REFERENCE:	Nova Bus Manuals
SECTION:	09 Engine
RS N°:	MQR 7621-515
EFFECTIVE IN PROD.:	L692-46 (2012DE)

SUBJECT:	Hydraulic system
JUSTIFICATION:	Hydraulic fluid may leak from loose connections in the radiator compartment, and at the hydraulic manifold block.

Figure 1 - Partial View of the Hydraulic System

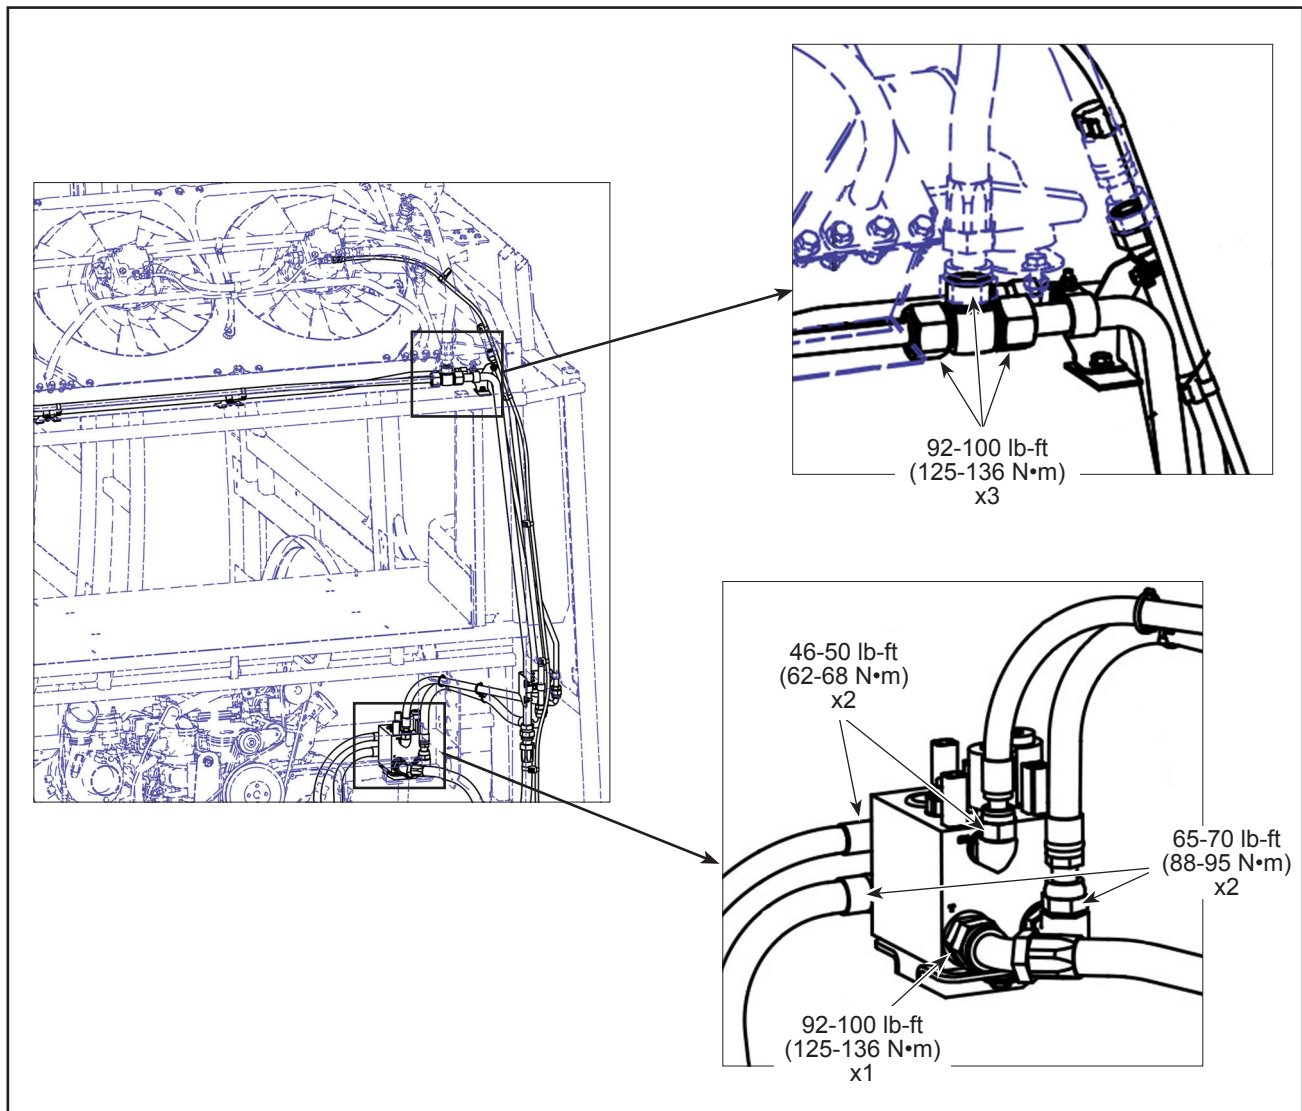
1.1. Retighten to the torque values indicated in Figure 1. ❖

LEVEL	DESCRIPTION	DIRECT CHARGES		TIME
		LABOUR	MATERIAL	
1	Retighten the hoses to the specified torque values.	Nova Bus	Nova Bus	30 min
2	-	-	-	-
